September 13, 2021

Pearl High School Indoor Training Facility
Pearl, Mississippi

ADDENDUM NO. 03

SINGLE PHASE MOTORS: SHALL BE CAPACITOR-START. ALL SINGLE PHASE MOTORS SHALL BE PROVIDED WITH THERMAL PROTECTION. SINGLE PHASE MOTORS SHALL HAVE AN ON WINDING SENSOR WITH AUTOMATIC RESET.

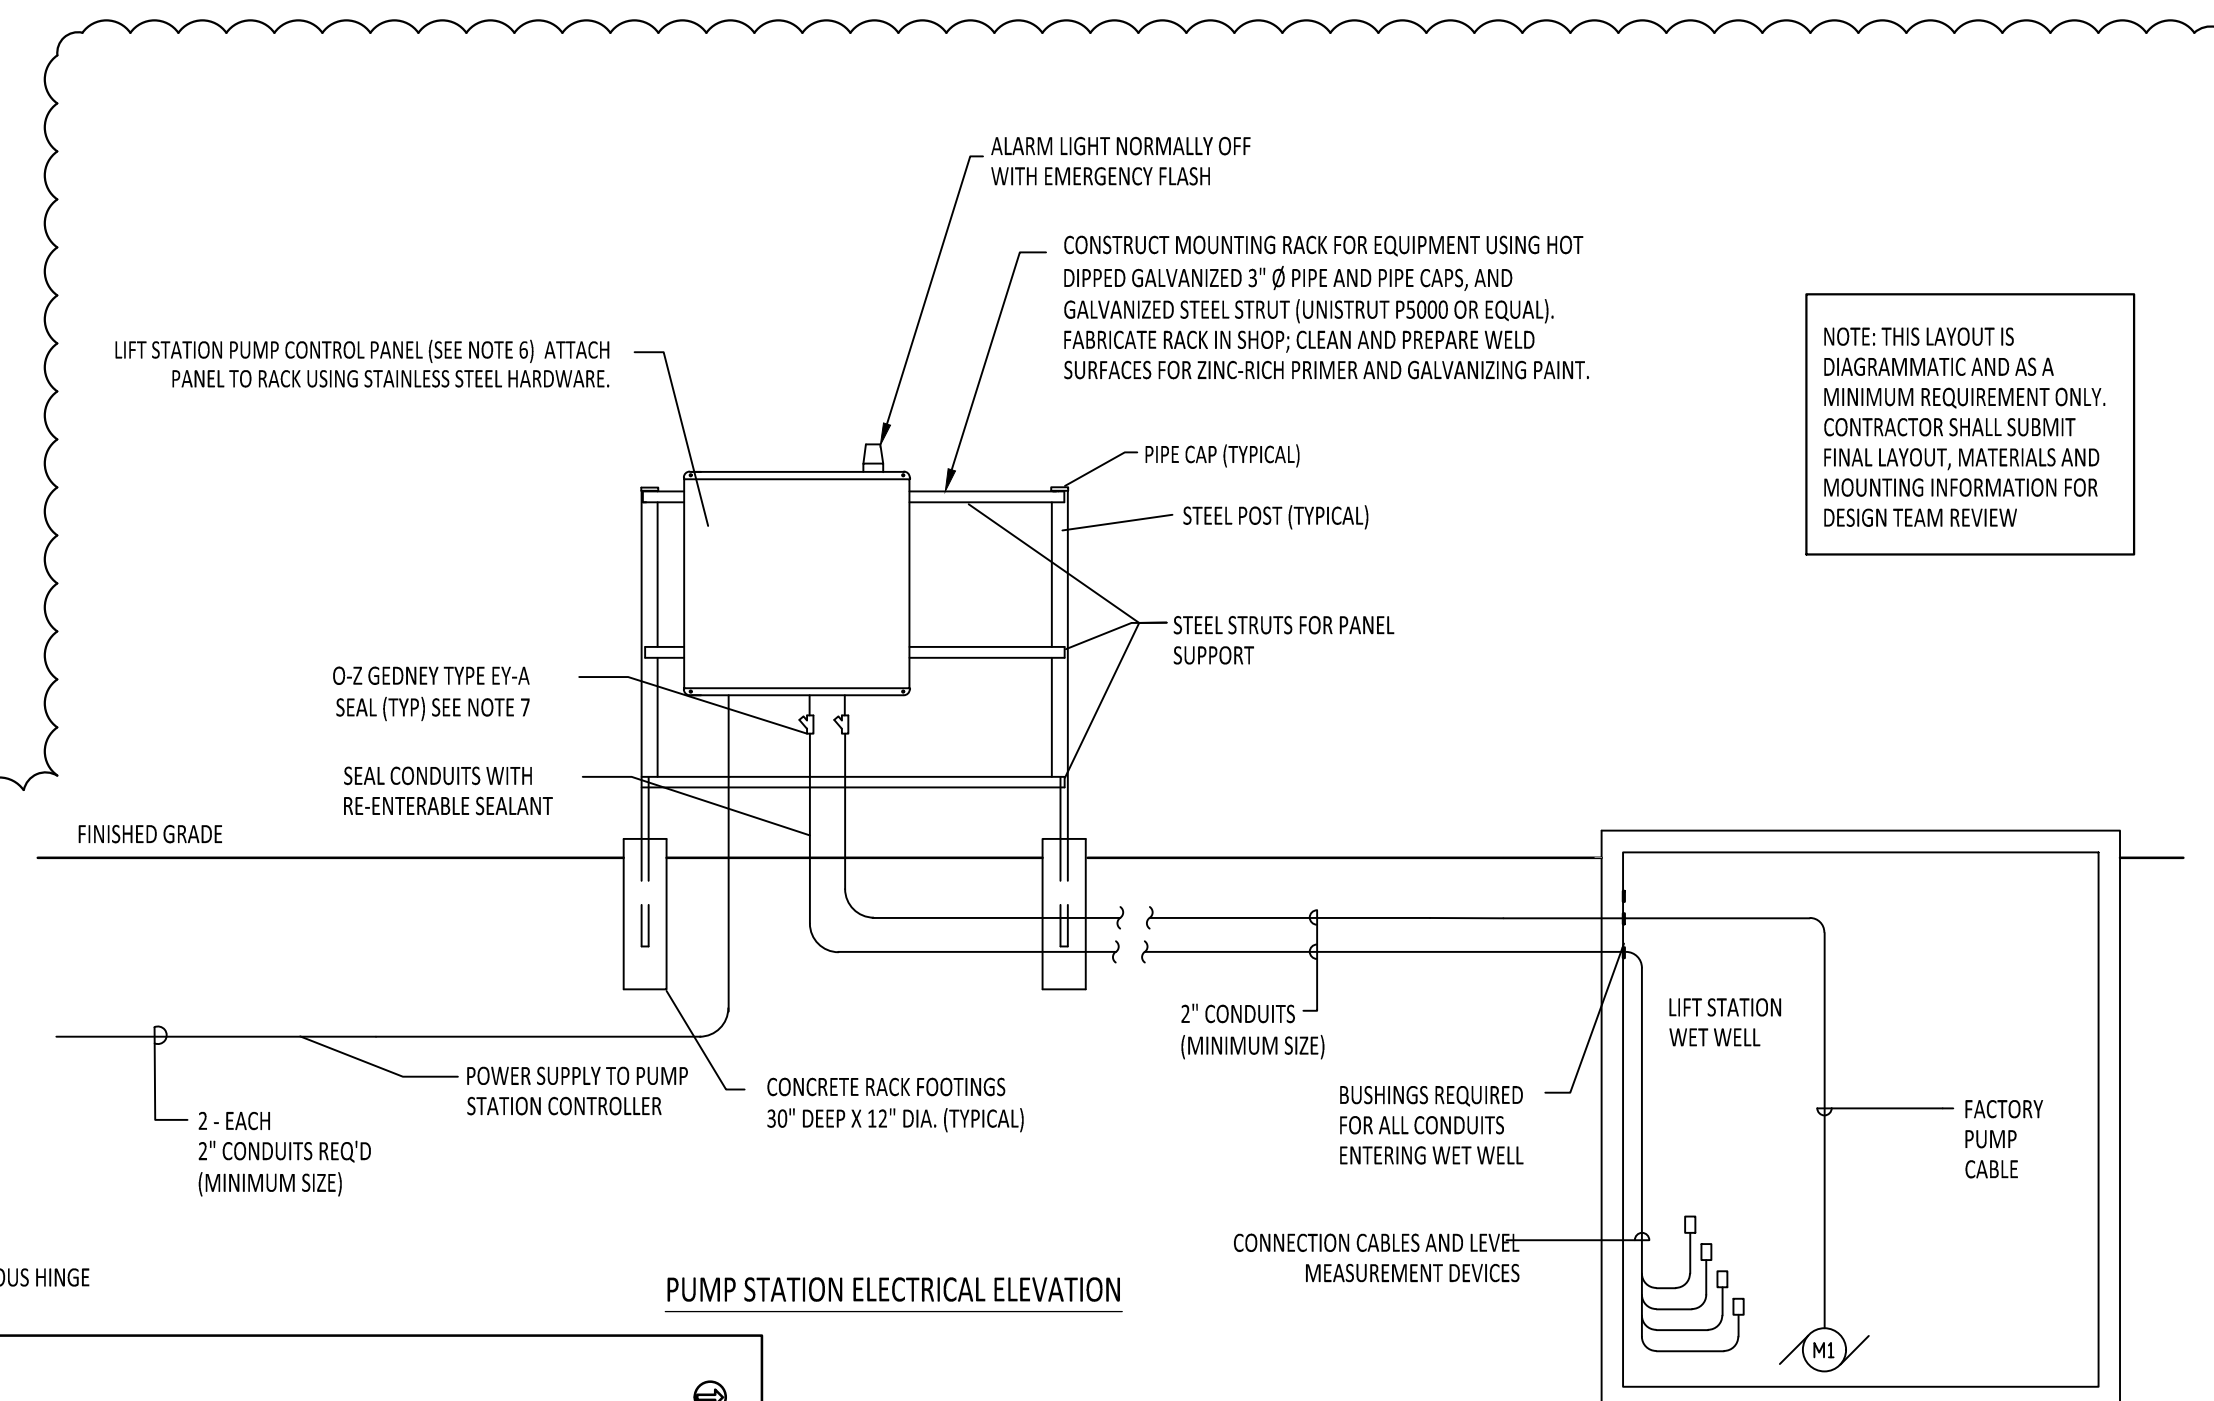
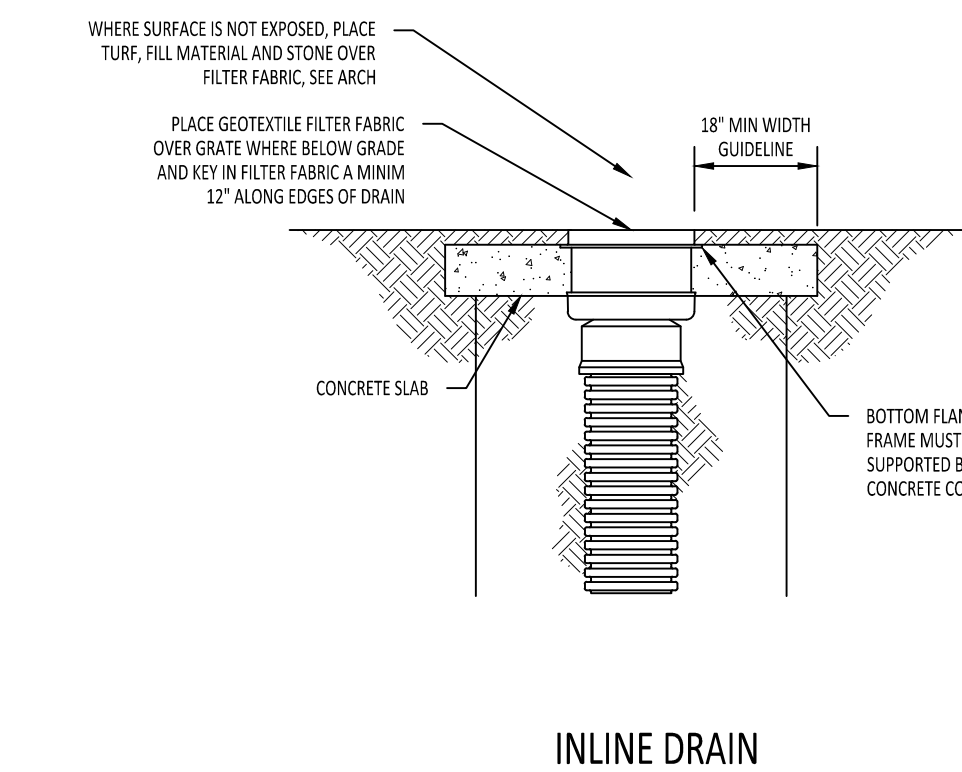
C205 CIVIL DETAILS

Revise per the enclosed sheets

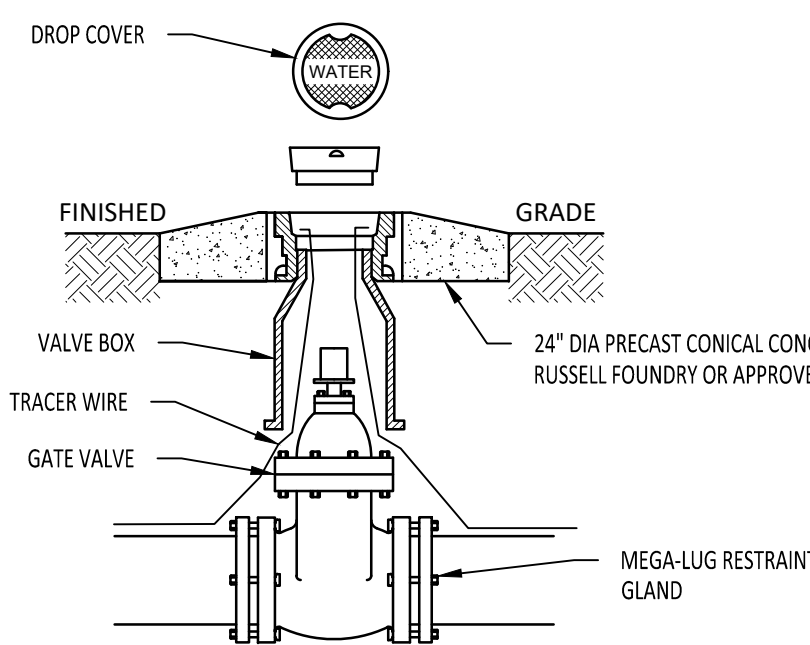
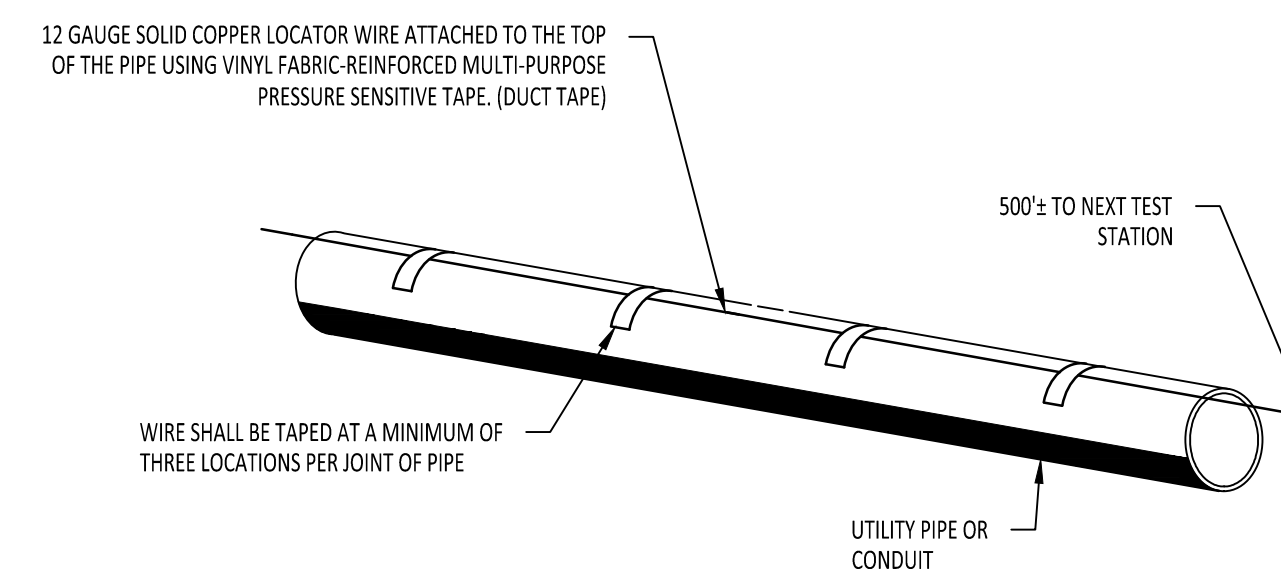
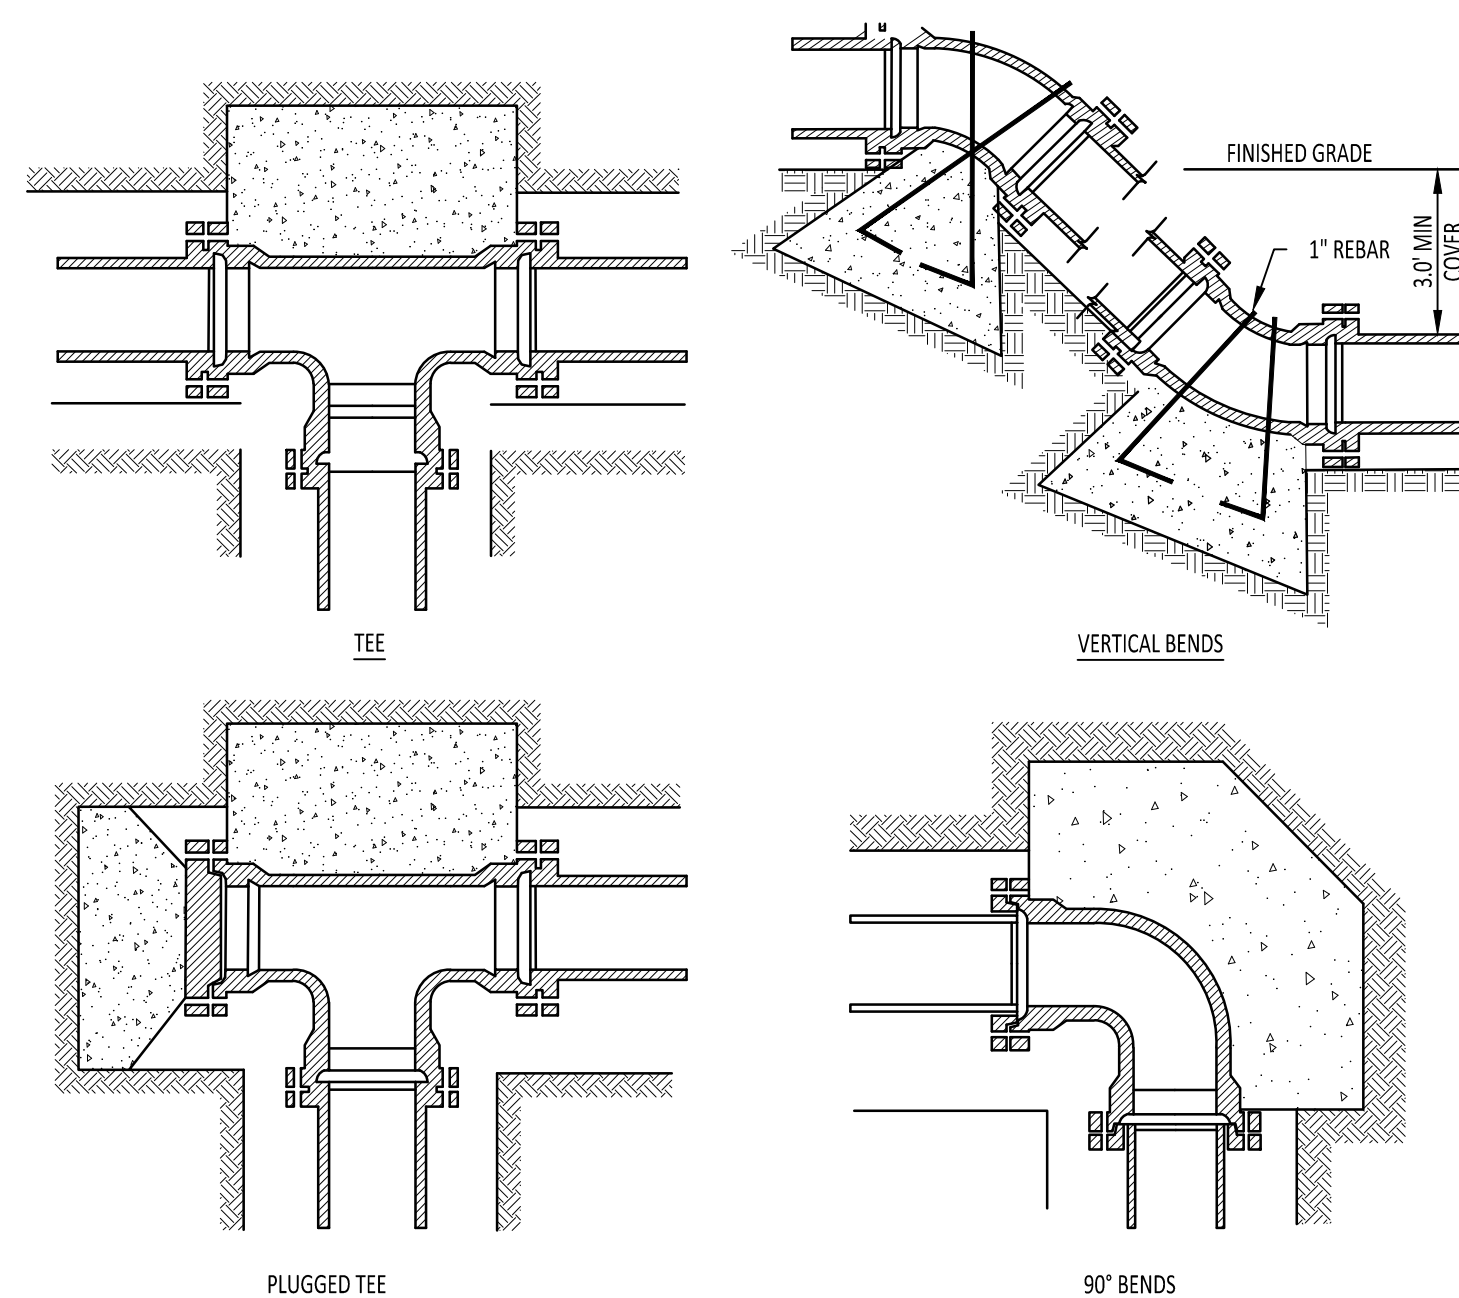
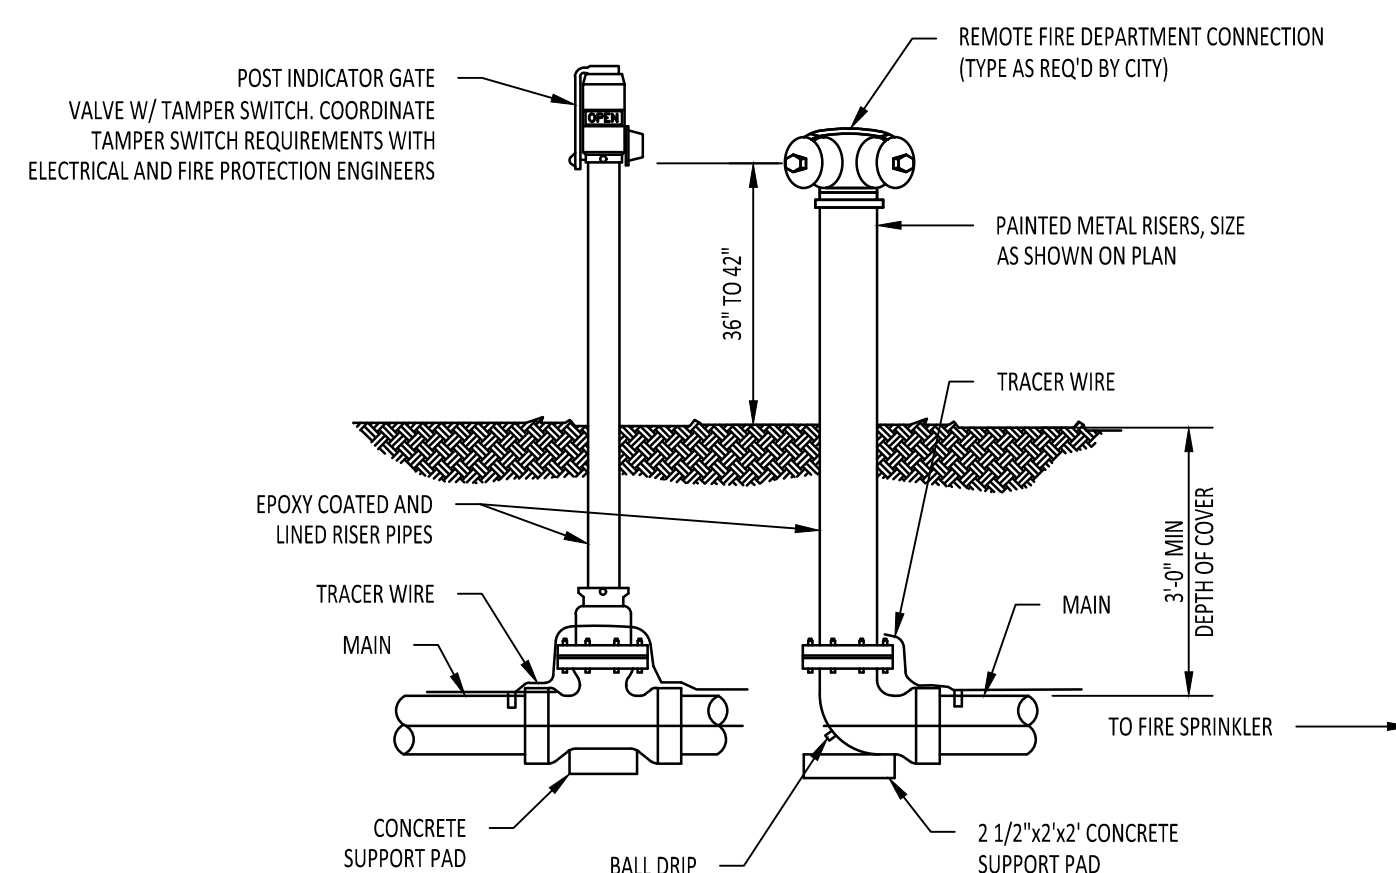
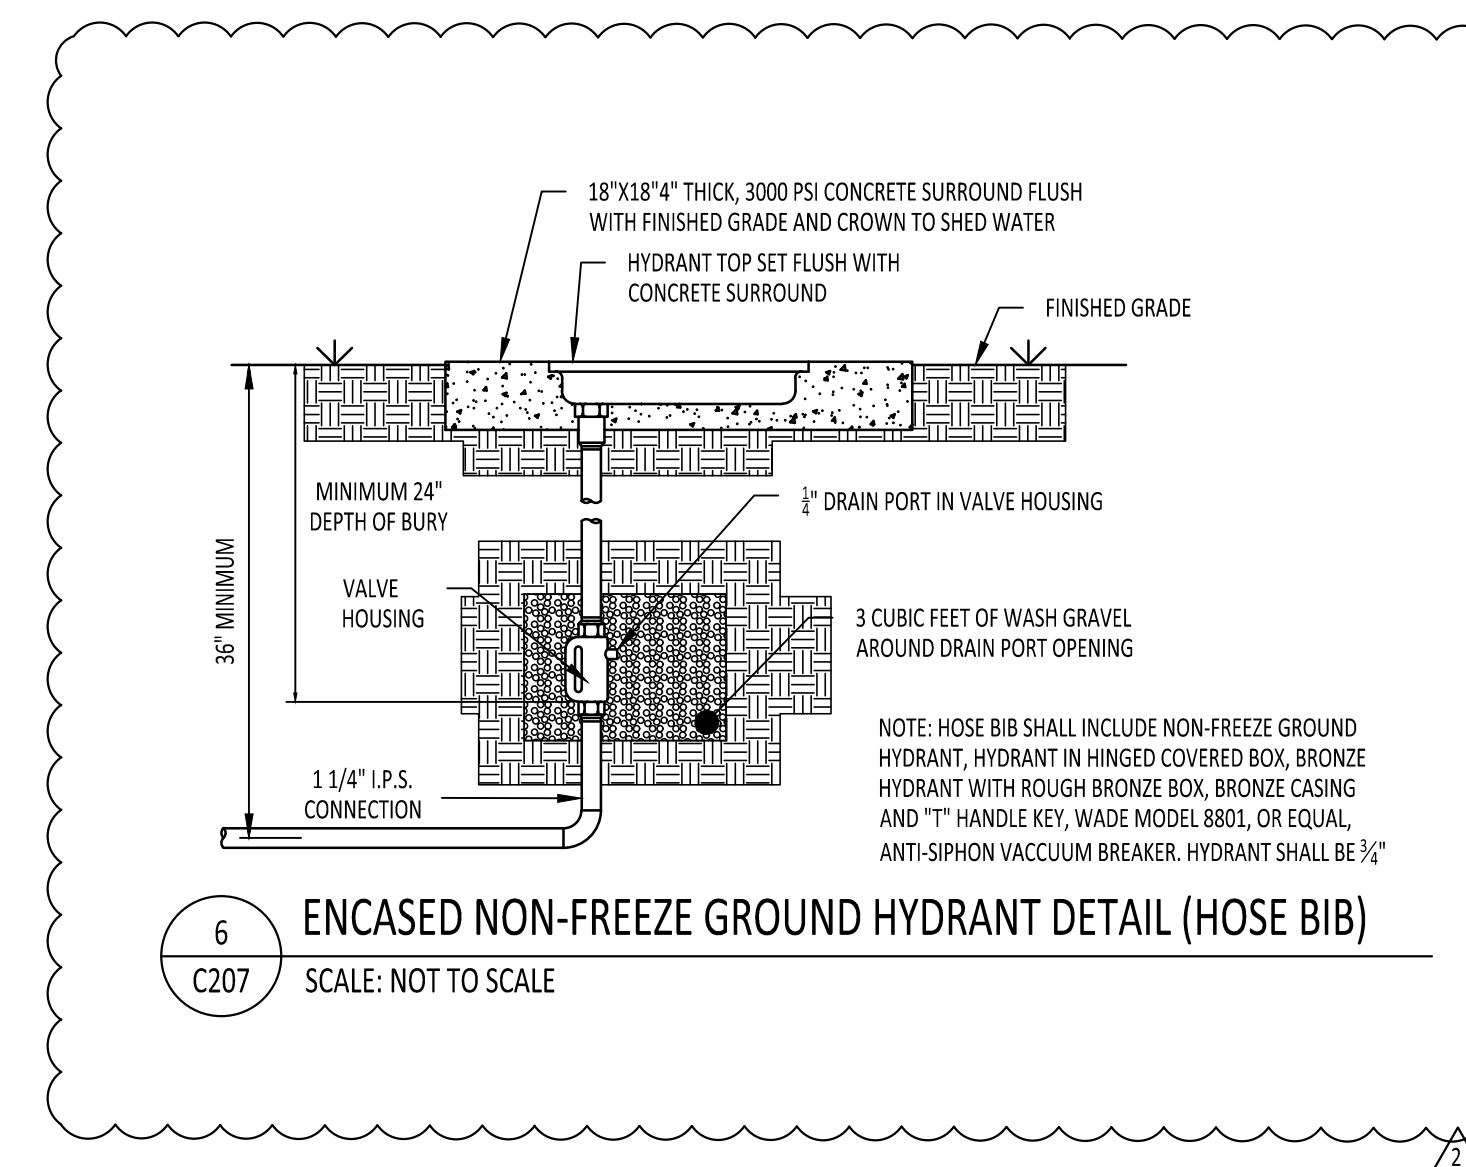
C207 CIVIL DETAILS
